Re: 2217 ST. Joe Industrial Park Rd Building Addition

SITE PAVING PLAN
1" = 30'

DRAINAGE REPORT

TRI-STATE PAINTING STORAGE BUILDING
2217 ST. JOSEPH INDUSTRIAL PARK DRIVE, EVANSVILLE, IN 47720

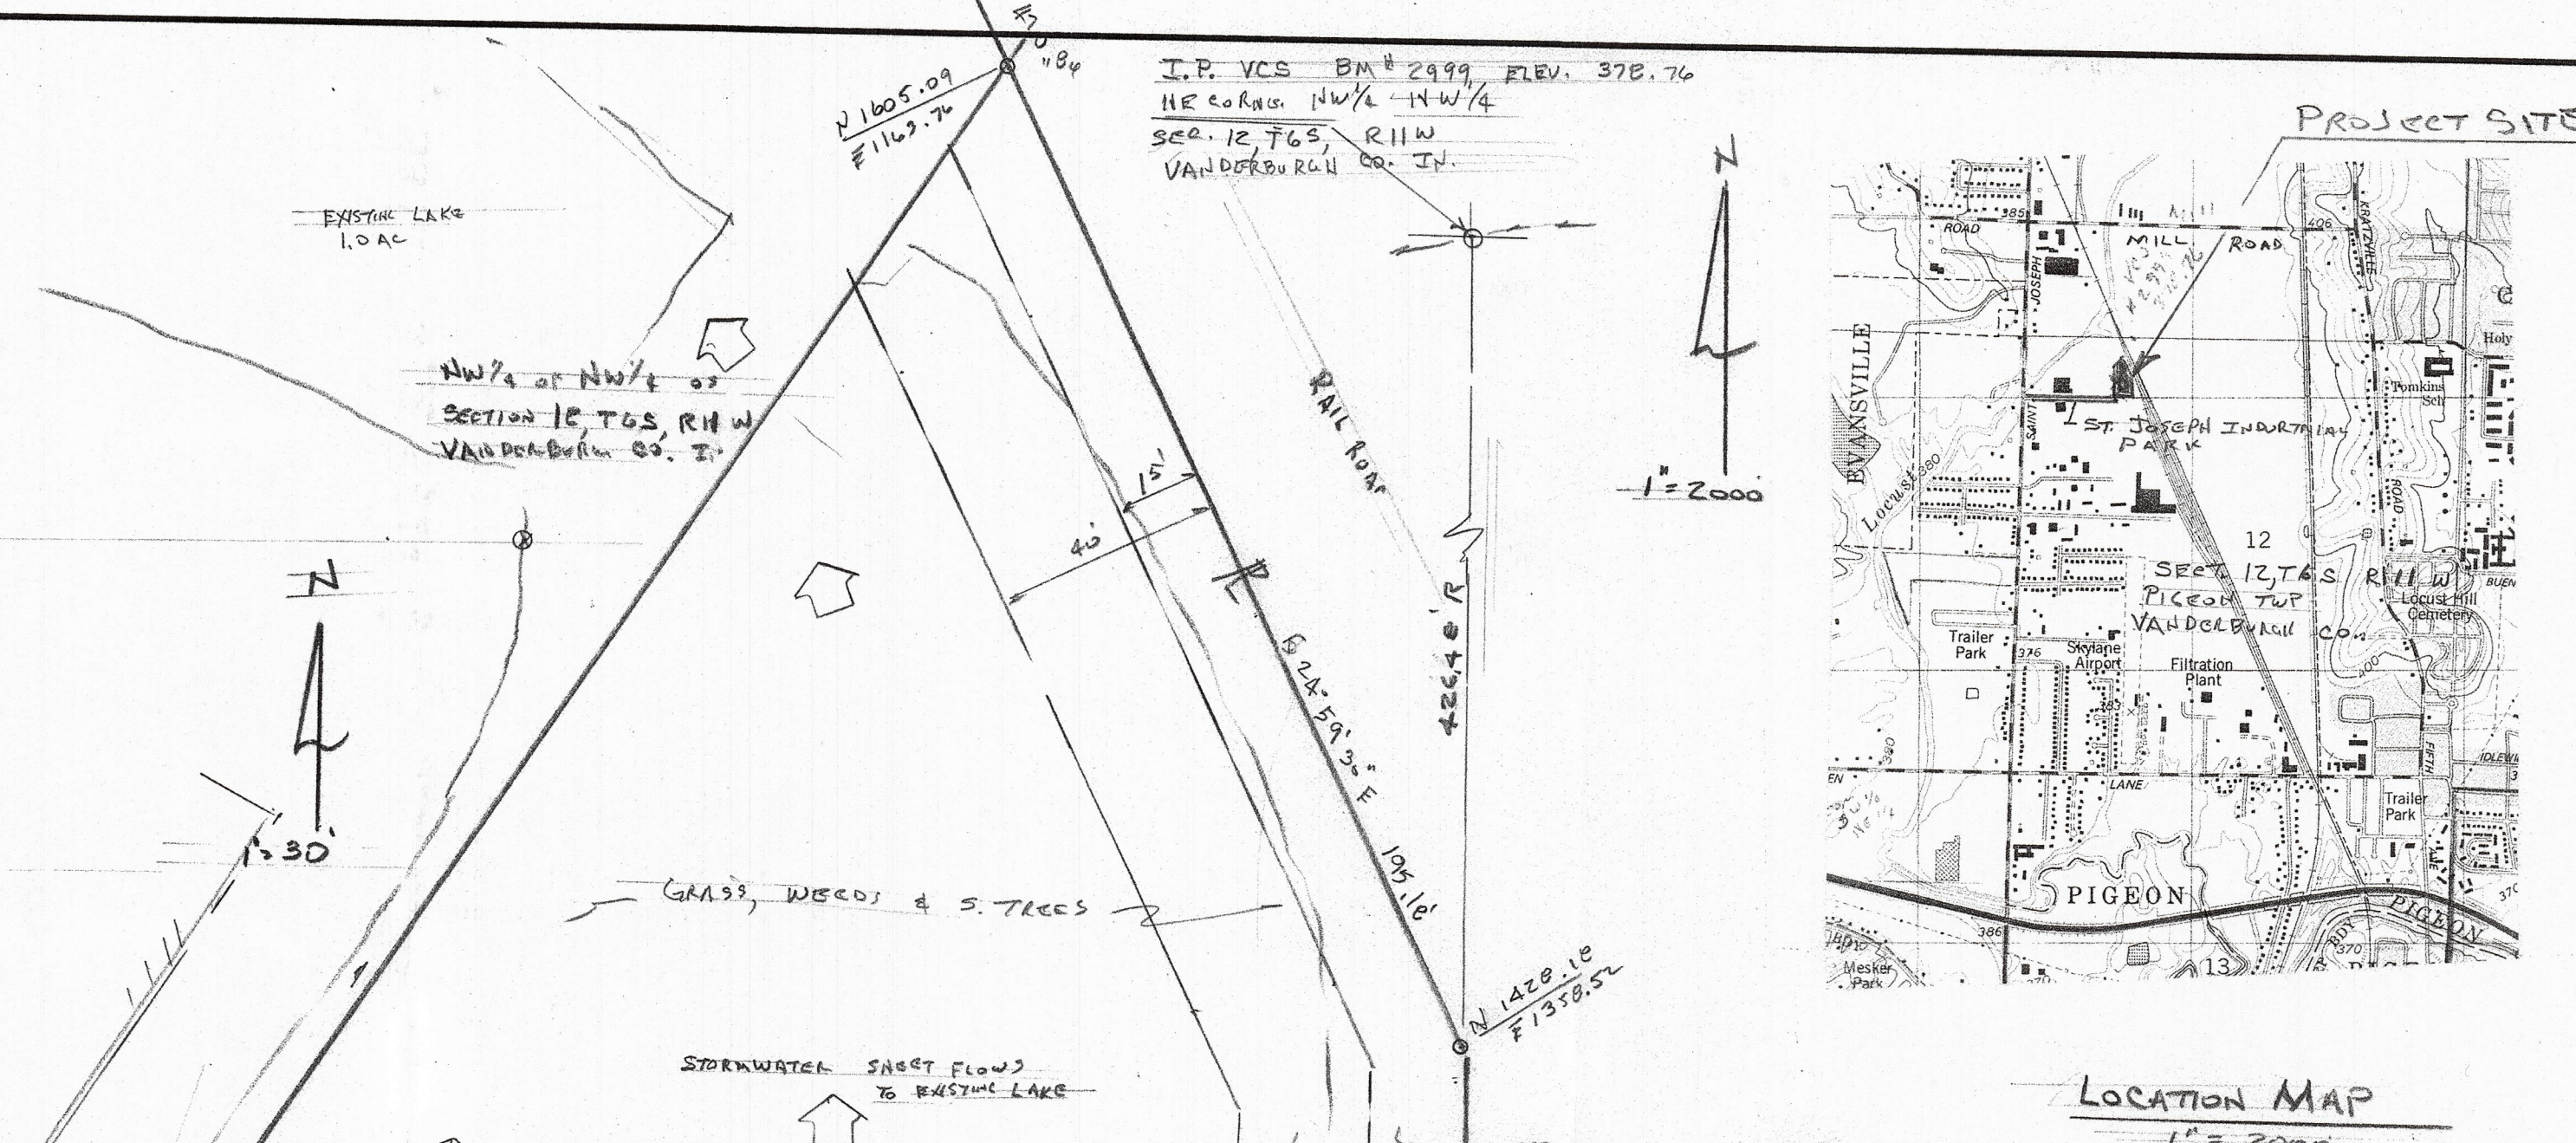
REMOVE or apply for encroachment
EXISTING CR STONE
IN DRAINAGE EASEMENT WITH SIMILAR SIDE SLOPE TO BANK
